Historic Preservation Commission

June 11, 2020

Demolition Review

Certificate of Appropriateness

423 Gwendolyn Drive NE – Accessory Structure

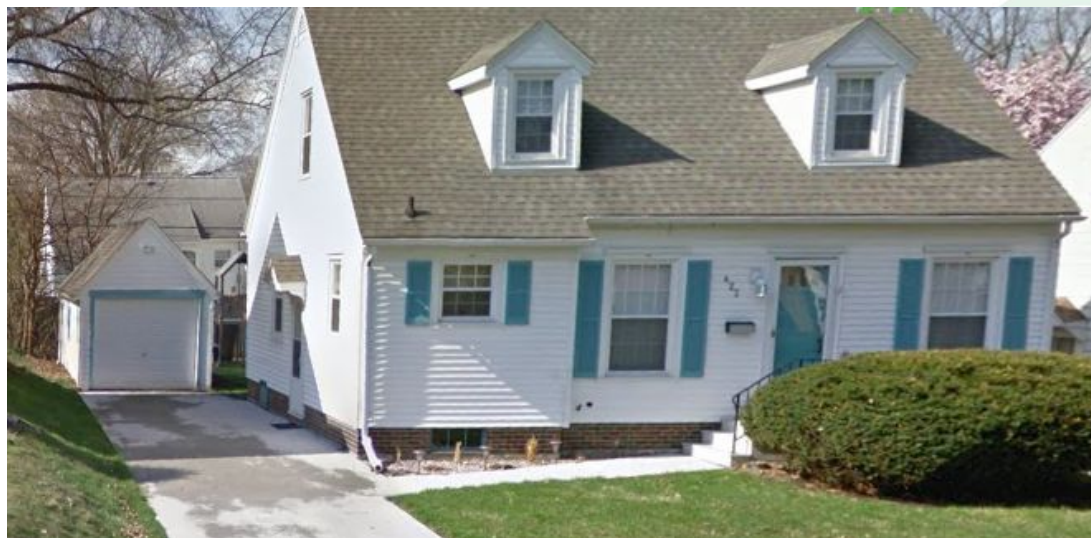
- Garage built in 1939. It is listed as normal condition per City Assessor
- This property was surveyed in the 2014 Citywide Reconnaissance Survey and was deemed not eligible.

- No evidence of historic significance and poor candidate for local landmarking
- Staff recommends immediate release

1720 3rd Avenue SE –Door Replacement

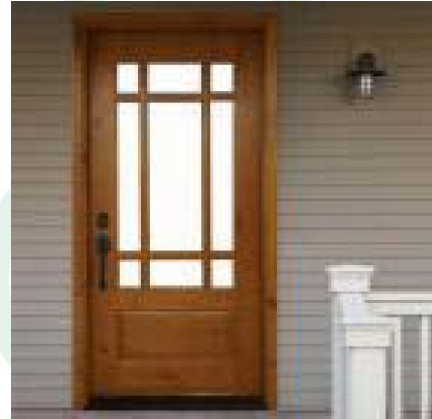
- Home built in 1900
- Located in the 2nd and 3rd Avenue Historic District
- The applicant would like to replace front porch door with a new 36" x 80" nine lite wood door. The applicant stated that in order to fit in the doorjamb, narrower windows to either side will have to be installed. The right window will be 23" x 57" and the left window will be 18" x 57"
- The alterations in size are to make the door more secure

- Staff recommends approving the COA for the door because the guidelines allow for replacement wood doors and the applicant is re-sizing the opening to make the door more secure.
